ATTACHMENT 1

PROPOSED CHANGES TO THE
GRAND GULF NUCLEAR STATION
TECHNICAL SPECIFICATIONS

NRC TECHNICAL REVIEW BRANCH: ACCIDENT EVALUATION

Figure 3.4.6.1-1

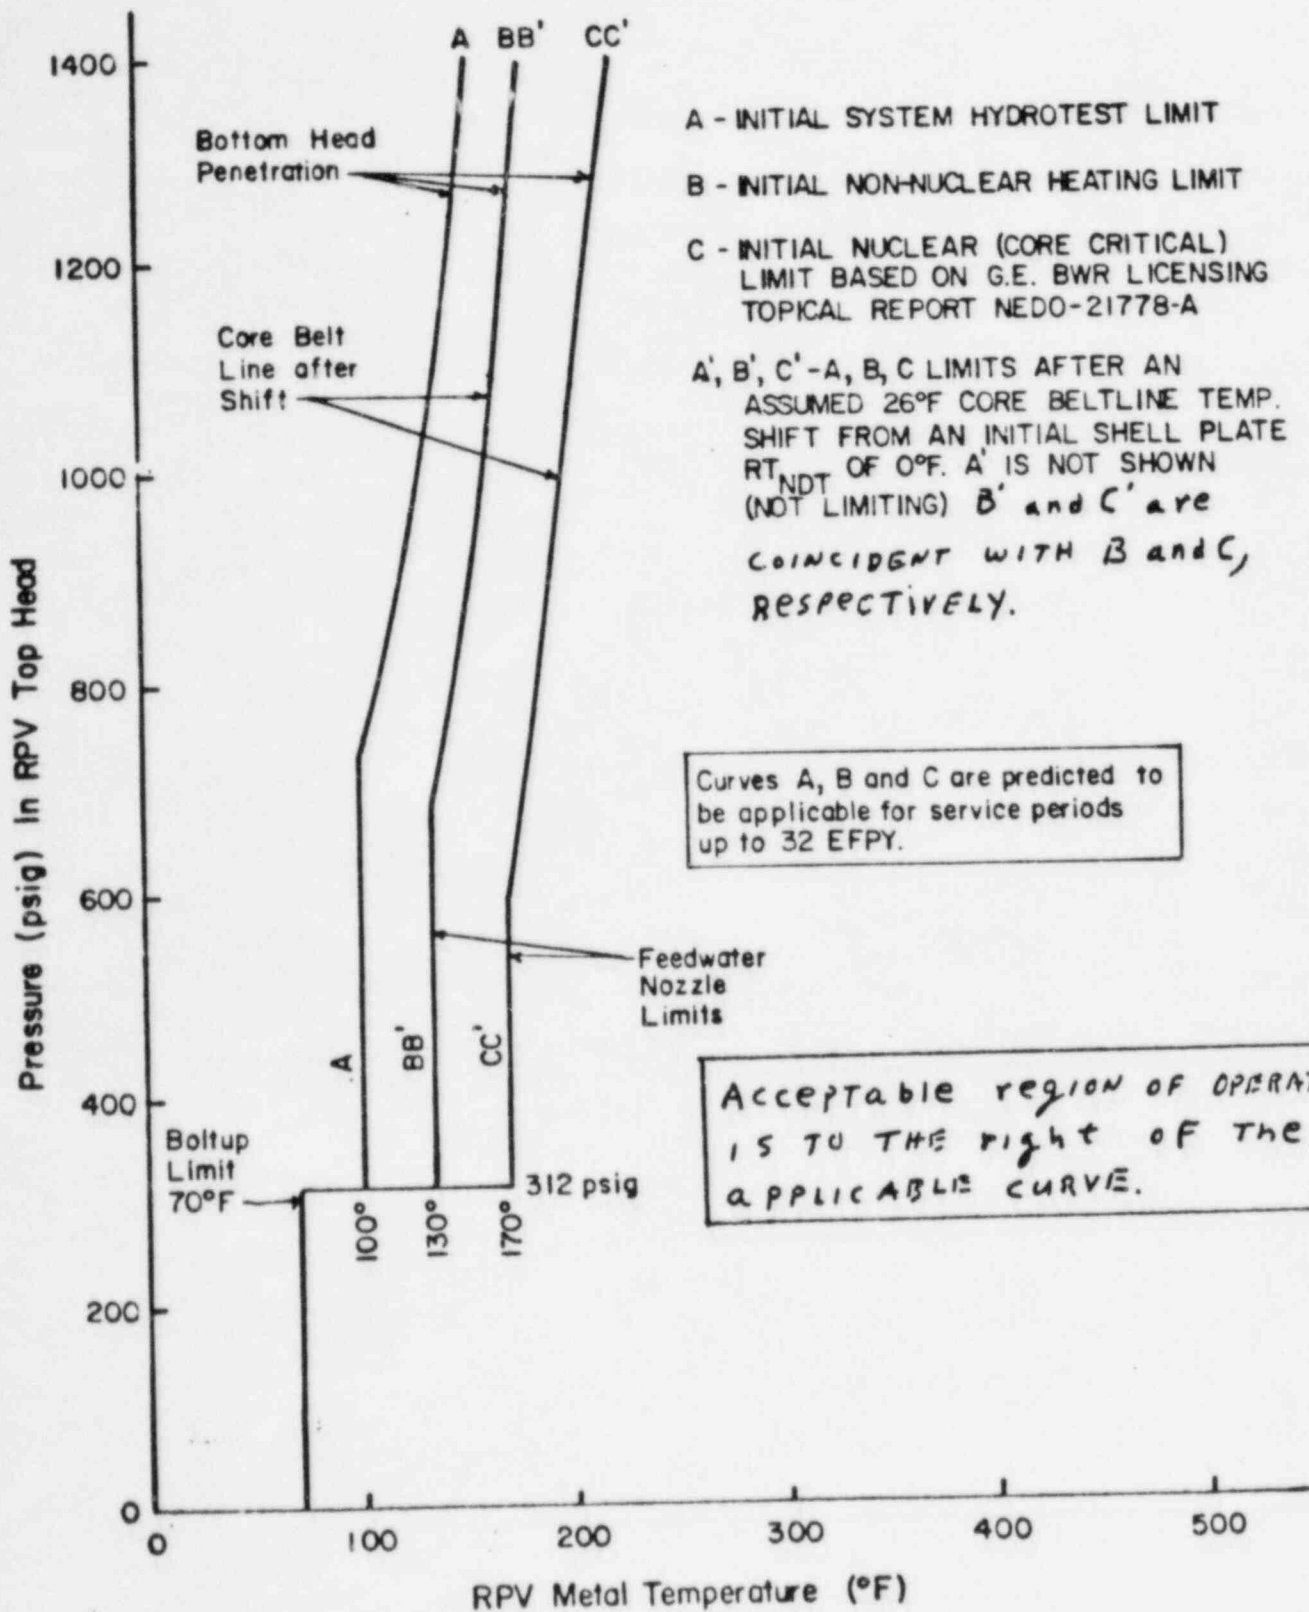
The proposed change to this specification is to clarify that reactor vessel metal temperature rather than reactor coolant system temperature is to be used in conjunction with Figure 3.4.6.1-1. This will make the specification consistent with the figure which is based on vessel metal temperature. The specification is further revised to refer specifically to reactor coolant temperature for the maximum heatup/cooldown rates. This is conservative, since the coolant temperature will change more rapidly than the vessel metal temperature. Additionally, it is proposed to revise Surveillance Requirement 4.4.6.1.3 to indicate that reactor vessel material specimens will be removed and examined in accordance with Appendix H of 10 CFR 50 and to renumber Surveillance Requirements 4.4.6.1.3 and 4.4.6.1.4 so that requirements dealing with temperature measurement and requirements dealing with materials testing are grouped together appropriately. This proposed change also adds Specification 4.4.6.1.5 to require removal and examination of the reactor flux wire specimens during the first refueling outage for determination of pressure vessel fluence as a function of time and power level. This is consistent with current industry practice, since flux wires contain fewer impurities than material specimens and therefore provide a more accurate indication of neutron fluence. Also, for further clarification, Figure 3.4.6.1-1 is revised to indicate that

the region of acceptable operation is to the right of the curves and that B' and C' are coincident with B and C, respectively. Bases 3/4.4.6 is also revised to maintain consistency with the proposed change and to clarify that the revised figure complies with 10 CFR 50, Appendix G. This proposed revision provides consistency with GGNS FSAR Section 5.3.2.1. This change improves the safety of the plant by clarifying certain requirements, assuring conformance with current regulations, and assuring consistency with the plant as described in the safety analyses. (Pages 3/4 4-17, 3/4 4-18, 3/4 4-19, B 3/4 4-4, and B 3/4 4-5)

This proposed change revises the curves of Figure 3.4.6.1-1 to conform to the revised requirements of 10CFR50, Appendix G, paragraph IV.A.2 and 3, (May, 1983); also, a statement is added to Bases 3/4.4.6 to indicate that the RT_{NDT} for welds and base material in the closure region is equal to or less than 10°F and that the initial hydrostatic test pressure was 1563 psig. The curves presently in the technical specifications conform with the requirements of the previous revision of Appendix G, with the exceptions noted in GE BWR Licensing Topical Report NEDO-21778-A. The proposed curves are in compliance with the revised Appendix G requirements to maintain the appropriate margins (as defined in the revised IV.A.2) above the bolt-up reference temperature at pressures exceeding 20 percent of the preservice system hydrostatic test pressure. For pressures below 20 percent of the preservice hydrostatic test pressure, the proposed curves meet the requirement to maintain a 60°F margin above the bolt-up reference temperature, as defined in paragraph IV.A.3. It is therefore concluded that this change is in compliance with 10CFR50, Appendix G requirements and is in accordance with recent NRC guidance to implement the May, 1983 revisions to Appendix G in the Grand Gulf Technical Specifications. (Page 3/4 4-19 and B 3/4 4-4)

The reactor vessel materials have been tested to determine their initial RT_{NDT} . The results of these tests are shown in Table B 3/4.4.6-1. Reactor operation and resultant fast neutron, E greater than 1 Mev, irradiation will cause an increase in the RT_{NDT} . Therefore, an adjusted reference temperature, based upon the fluence, phosphorus content and copper content of the material in question, can be predicted using Bases Figure B 3/4.4.6-1 and the recommendations of Regulatory Guide 1.99, Revision 1, "Effects of Residual Elements on Predicted Radiation Damage to Reactor Vessel Materials." The pressure/temperature limit curve, Figure 3.4.6.1-1, curves A', B' and C', includes predicted adjustments for this shift in RT_{NDT} for the end of life fluence as well as adjustments for possible errors in the pressure and temperature sensing instruments. *Curves B' and C' are coincident with curves B and C, respectively.*
